Access Compliance Report

Public Rights-of-Way

Intersection ID: 50617	Main Street: GOLDEN_WOOD_LN	Cross Street: PADDLE_OAK_RD	Location: SW
ADA ID: 49E23C2581D5	Ramp Type: Perp	Initial Pass/Fail: Fail	Overall Compliance: No
Severity Score: 35			
Codes/Mitigation Info/Possible Solution		Field Measurements/Component Compliance

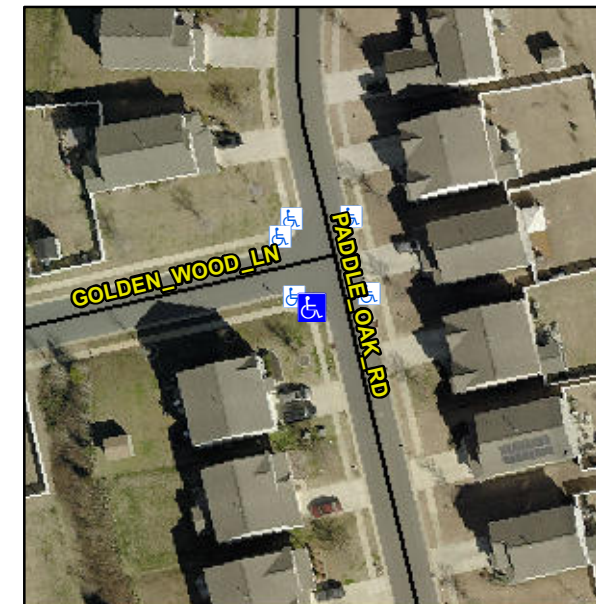
Possible Solutions:

Remove & Replace Entire Ramp.

R304.5.1, R304.2.2, R304.5.3

Compliance	Description	Data	Compliance	Description	Data
N/A	Ramp Length (in)	47.0	No	Ramp Slope (%)	12.3
No	Ramp Width (in)	47.5	No	Ramp XSlope (%)	4.4
N/A	Flare Type LT	N/A	N/A	Flare Type RT	N/A
N/A	Flare Slope LT (%)	N/A	N/A	Flare Slope RT (%)	N/A
N/A	Flare Traversable LT?	N/A	N/A	Flare Traversable RT?	N/A
N/A	Landing Length (in)	N/A	N/A	DWS Provided?	N/A
N/A	Landing Width (in)	N/A	N/A	DWS Contrast?	N/A
N/A	Landing Slope (%)	N/A	N/A	DWS Length (in)	N/A
N/A	Landing X Slope (%)	N/A	N/A	DWS Full Width?	N/A
N/A	Landing Curb? (Y/N)	N/A	N/A	DWS Offset (in)	N/A
N/A	Shared Landing?	N/A			
N/A	Gutter Ponding?	N/A	N/A	Gutter Slope (%)	N/A
N/A	Gutter Lip Ht (in)	N/A	N/A	Gutter X Slope (%)	N/A
N/A	Painted X Walk1?	No	N/A	Painted X Walk2?	N/A
	X Walk 1 Direction	To E		X Walk 2 Direction	N/A
N/A	X Walk 1 Width (in)	N/A	N/A	X Walk 2 Width (in)	N/A
	X Walk 1 Slope (%)	2.3		X Walk 2 Slope (%)	N/A
	X Walk 1 X Slope (%)	3.4		X Walk 2 X Slope (%)	N/A
